Obstacle Lighting Plan and Aviation Response

February 2025

Our ref: 102211-02

Re: Junction Rivers Wind Farm – Obstacle Lighting Plan and EIS responses

Figure 1 Proposed obstacle lighting layout

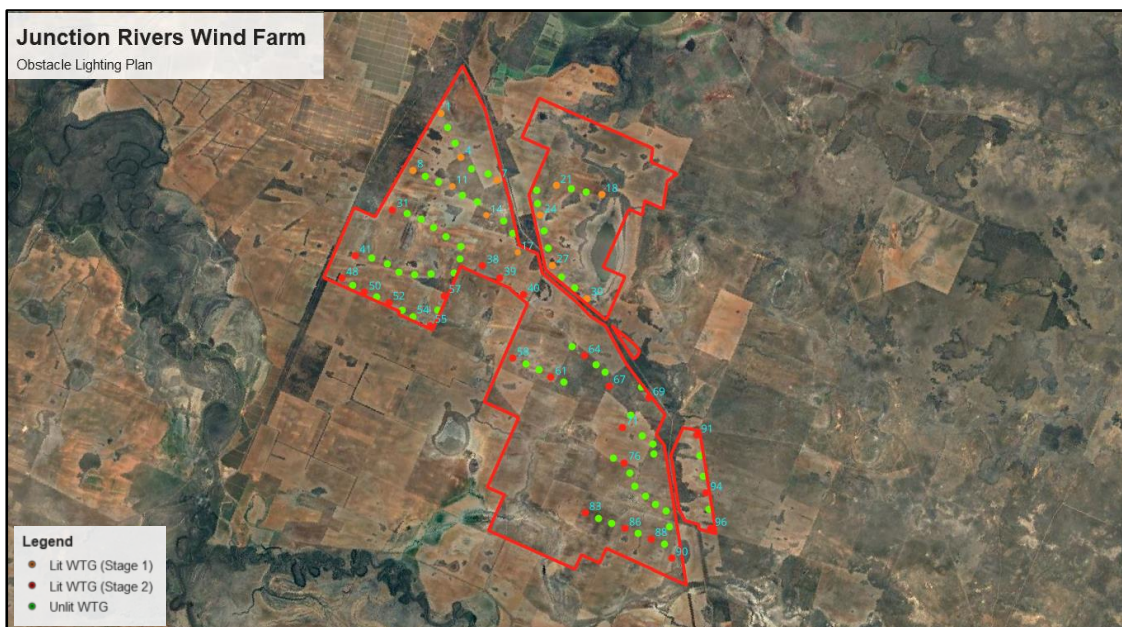
Contrary to Recommendation 9, CASA considers the proposed wind farm will be a hazard to aviation safety and recommends that the wind farm is obstacle lit with steady medium-low intensity red obstacle lighting in accordance with the National Airports Safeguarding Framework Guideline D 'Managing the Risk of Wind Turbine Farms as Physical Obstacles to Air Navigation' National Airports Safeguarding Framework Principles and Guidelines (infrastructure.gov.au) and section 9.31 of Part 139

International standards require 2,000 candela lighting intensity on the nacelle (also recommended in the NASF guideline) and 200 candelas at the mid-point of the turbine mast. CASA recommends that 200 candela as a minimum intensity lighting on the nacelle would suffice (due mainly to the lack of background lighting in the vicinity of the turbines). The obstacle lighting should be monitored to alert the wind farm operator of any outage and at least some of the obstacle lights remain on during an outage. CASA is prepared to review a lighting plan that indicates which turbines are proposed to be lit.

In applying the requirements of CASR Part 139 MOS or NASF Guideline D in relation to obstacle lighting on wind turbines, and in particular the 900 m interval, it is suggested that the following wind turbines (red dots and orange dots illustrated in Figure 1 and Table 1) are lit. The Junction Rivers Wind Farm should have 200 candela (cd) low intensity steady red obstacle lighting that is fitted and operational.
